From: Williams, Jeffrey
Sent: Friday, February 05, 2016 3:04 PM
To: 'Rosario DIMARCO'
Cc: Oswald, Hank
Subject: RE: RE: Dimarco Property Lot N.4
Attachments: 20160205143636058.pdf

ON SITE SEWAGE DISPOSAL SYSTEM DESIGN PLAN

FOR
**RE-BUILDING OF 11410 OLD FREDERICK ROAD
 MARIOTTSVILLE, MARYLAND 21104**

**RE: OSDS Plan Comments
Dimarco Property, Lot 4
Marriottsville, MD 21104**

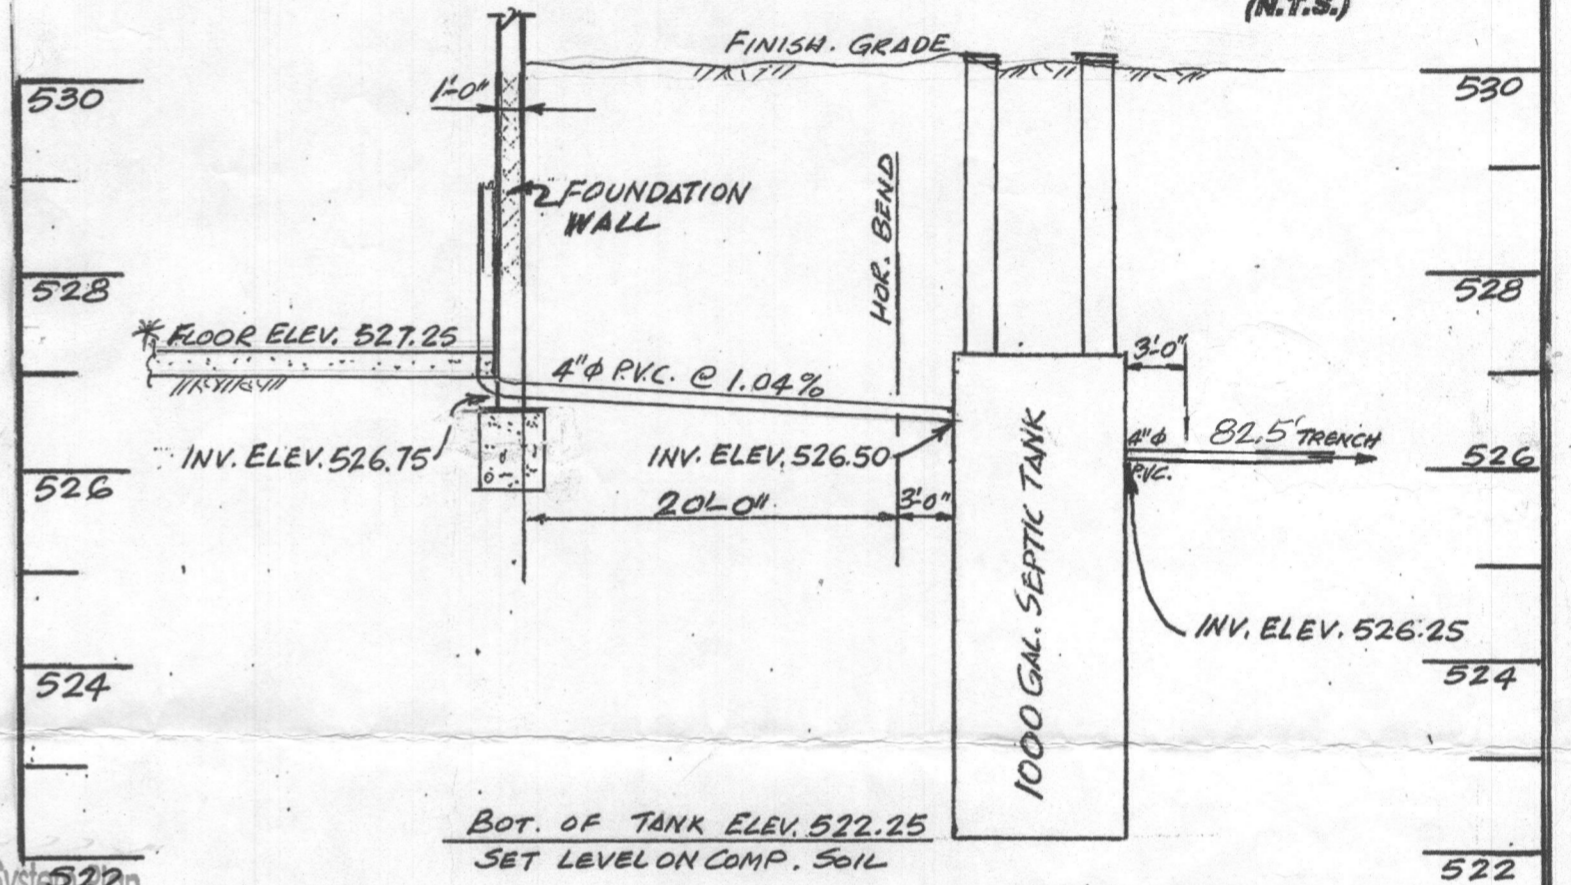
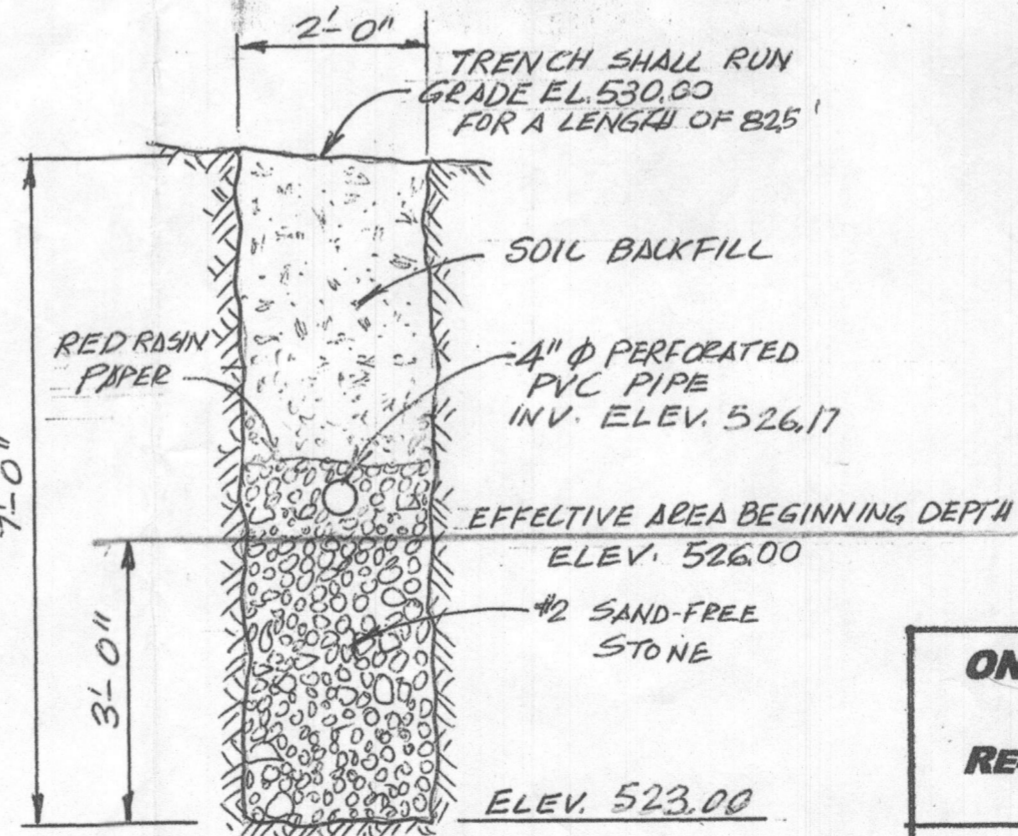
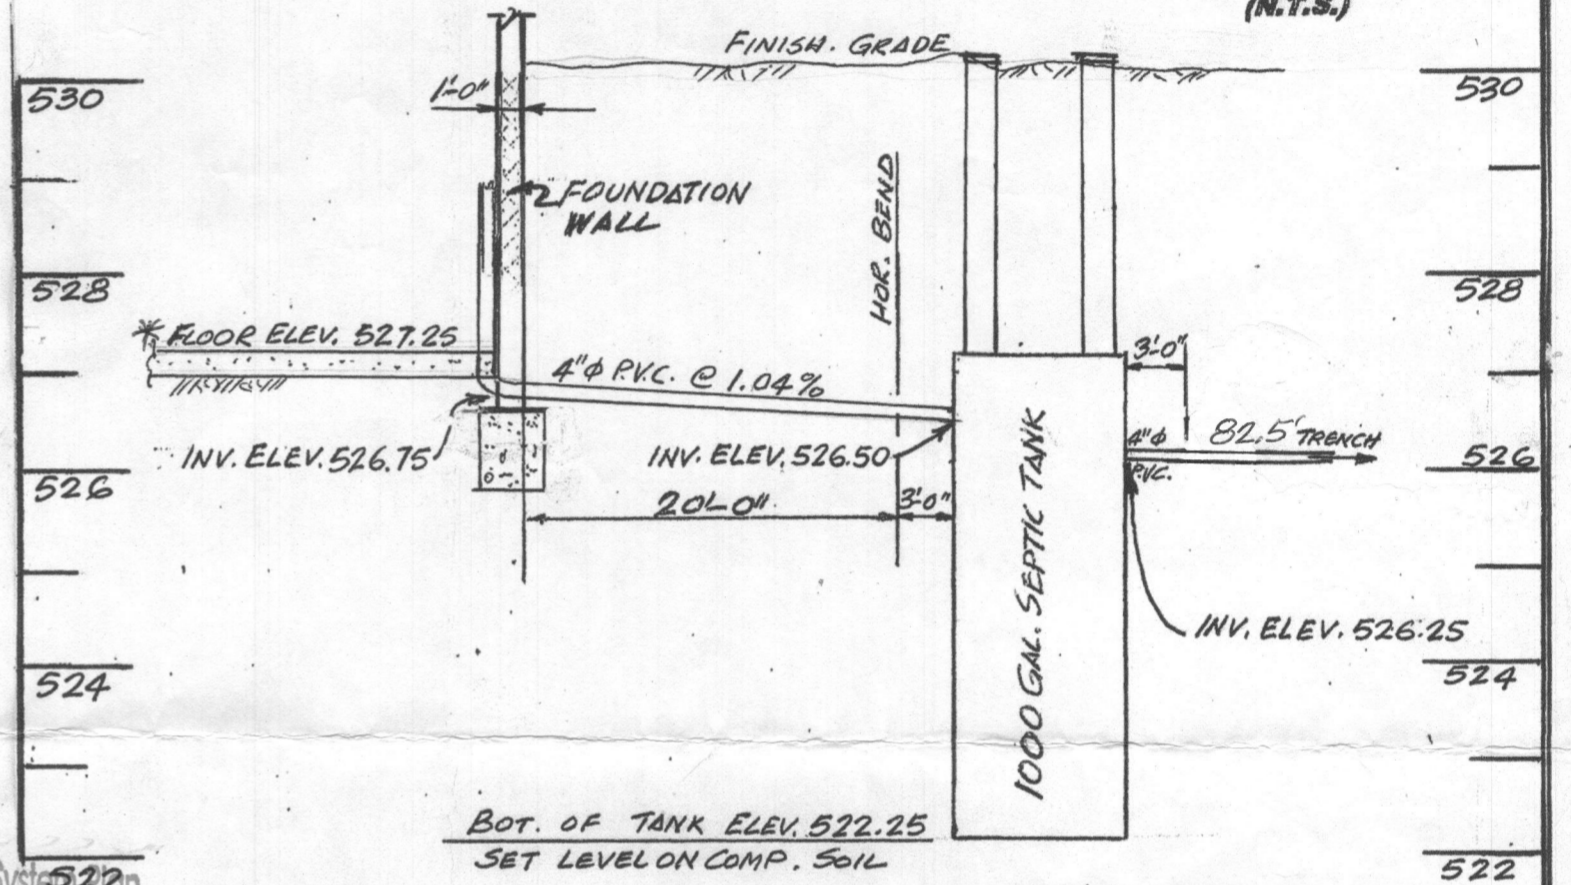
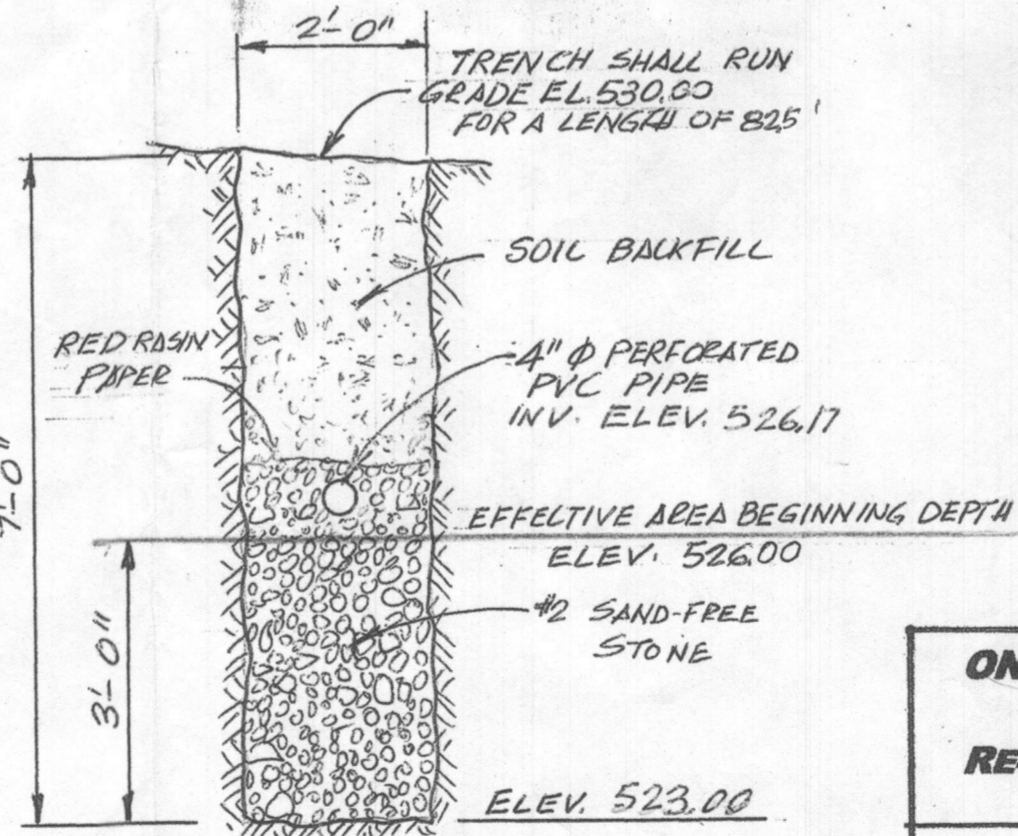
- According to the record plat signed on 6.23.77, the North Lot Line measures 184.98 ft. but your plan measures 185 ft. The South Lot Line measure 185.37 ft. but your plan measures 183 ft. The East Lot Line measures 263.32 ft. but your plan measures 255 ft. The West Lot Line measures 275 ft. but your plan 267 ft. Please revise the plan to match the record plat.

- As discussed, the two lower perc test holes were inaccurately plotted on the plan. Please revise the plan to match the signed record plat. Also, place the perc test hole #/locations on plan.

- According to public works, Lot 5 is not utilizing public water. Therefore, you will be required to show this well on your septic plan. It must be 100 feet from your SDA or you will be required to provide a revised Percolation Certification Plan (Please see attachment for perc cert plan requirements).

- The septic spec. for the initial system remains at 0.8 gpd due to surrounding perc test data above 5 gpd. Revise calculation and trench layout.
- Add note - Topography of this plan was taken from _____ and is verified to accurately represent the changes on the subject property.

- Show existing well on this lot and add symbol to legend.
- Add note - Existing well must be properly abandoned prior to building permit approval by the Health Department.

- Add note - This lot will be served by public water.
- Add note - All wells have been field located and accurately shown on the plan
- The SDA shown on this plan is less than 20 feet from the proposed house. Revise house location to meet 20 foot setback requirement or submit a revised perc cert plan. You may apply for a waiver to the setback but if a revised perc cert is required for any other reason, this setback requirement will have to be met.

- Show water line and easement on the septic plan. If any part of the water line/easement is less than 10 feet from the SDA, then that part of the water line must be sleeved. If any part of the water line runs through the SDA, a revised perc cert will be required.

REVISIONS - JUNE 1, 2017 - VARIOUS HEALTH DEPT. COMMENTS
